# Rezoning Application: PD 23-0109 (Remand)

February 20, 2024

#### AGENCY REVIEW COMMENT SHEET

PETITION NO: RZ 23-0109

## 8.0 PROPOSED SITE PLAN (FULL)

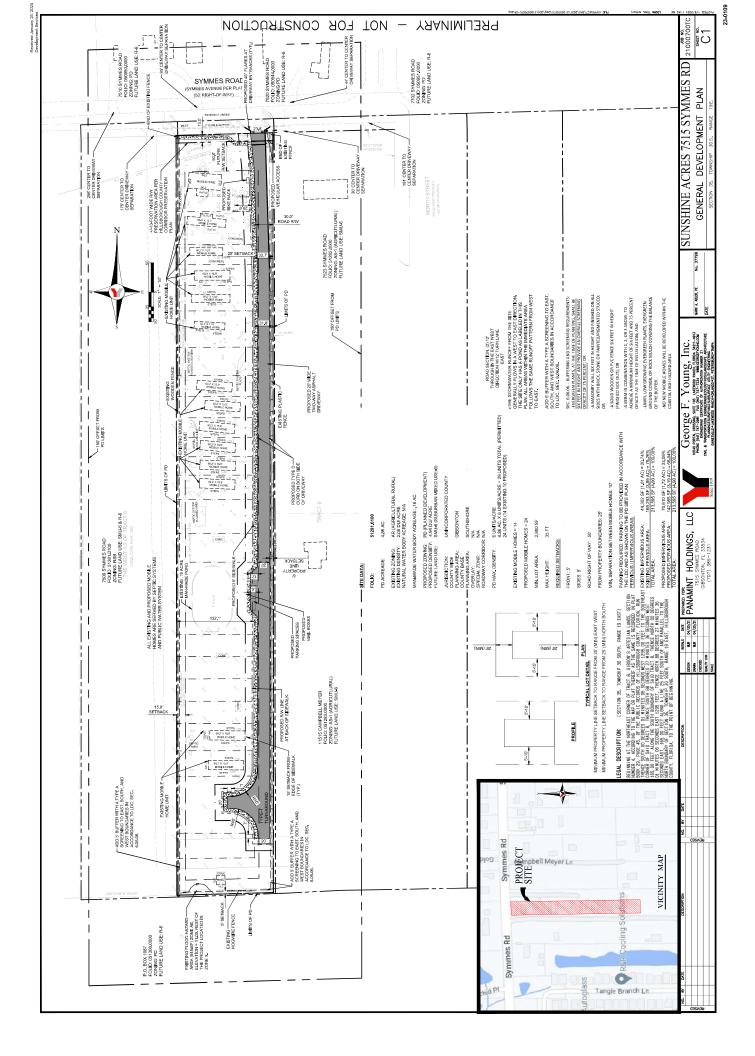
On November 7, 2023, the Board of County Commissioners approved the applicants request for a remand to address two concerns: 1) the removal of the vertical curbing on the east side of the driveway; and 2) to reduce the internal sidewalk from six feet to five feet wide. After discussing further with Transportation staff, the applicant is proposing a Type D curb on each side of the driveway and retaining the original 6-foot-wide sidewalk. Transportation staff have no objections.

- 7. Project access shall be limited to one (1) vehicular connection to Symmes Road Construction access shall be limited to those locations shown on PD site plan which are also proposed vehicular access connections. The developer shall include a note in each site/construction plan submittal which indicates same.

- b. No part of a mobile home shall be located within 15 feet of closest edge of the internal 6-foot-wide sidewalk shown on the PD site plan.
- 12. Wetlands or other surface waters are considered Environmentally Sensitive Areas and are subject to Conservation Area and Preservation Area setbacks. A minimum setback must be maintained around these areas which shall be designated on all future plan submittals. Only items explicitly stated in the condition of approval or items allowed per the LDC may be placed within the wetland setback. Proposed land alterations are restricted within the wetland setback areas.

Prior to site plan certification, the applicant shall revise the PD site plan to:

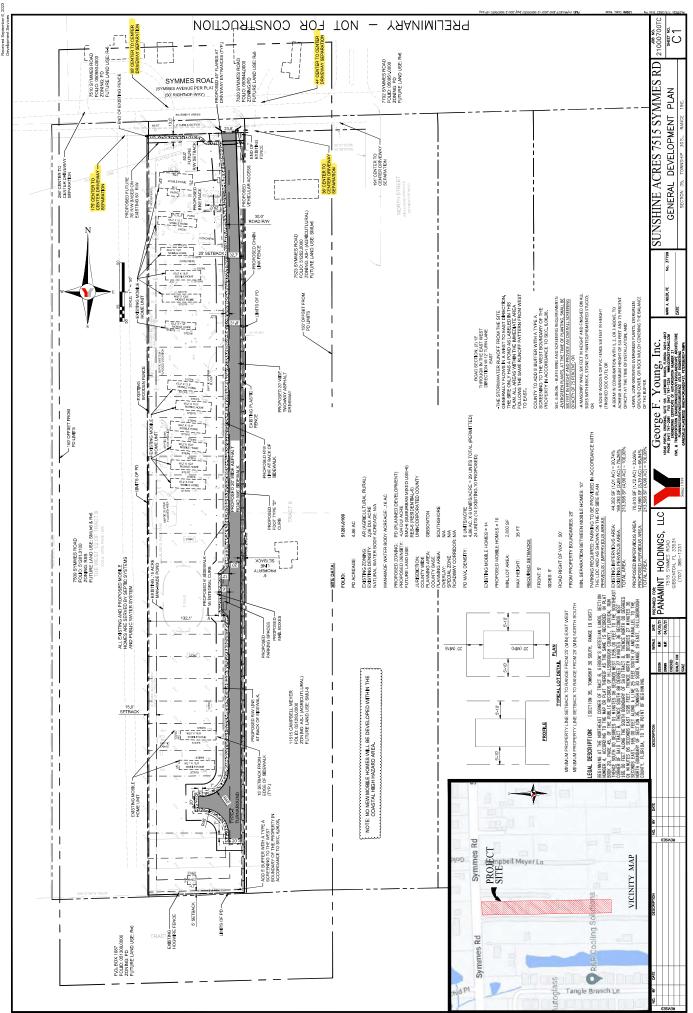
Refer to attached proposed site plan showing distances between driveways.

Based on Section 6.04.07 of the Hillsborough County Land Development Code states that for a Class 4 roadway, a minimum connection distance of 330 ft for speed of 45 mph or less is required. The existing development has only one access driveway along Symmes Road. The total roadway frontage along Symmes Road for the development is approximately 80 feet. Even relocating the driveway to any point along the 80 ft of roadway frontage will not provide the required 330 ft separation required to any of the existing driveway within the area.

Approved with Conditions
